REMARKS

The present invention relates to an adhesive label comprising a circuit substrate, electronic components formed on at least one surface of said circuit substrate, and an adhesive layer on said electronic components.

AMENDMENT UNDER 37 C.F.R. § 1.111 U.S. Appln. No. 09/830,605

FIG. 3

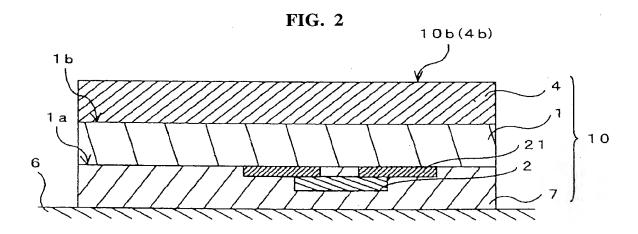
The Examiner has not explicitly indicated that the drawings submitted on April 30, 2001 have been accepted. Applicants respectfully request the Examiner make such an acknowledgment. Applicants submit herewith a proposed drawing correction, wherein Fig. 3 has been amended to recite --Prior Art-- (highlighted), to clearly indicate that Fig. 3 is directed to the structure of a typical conventionally used adhesive label-type data carrier. Such an amendment is supported by the specification at, for example, pages 1 to 4.
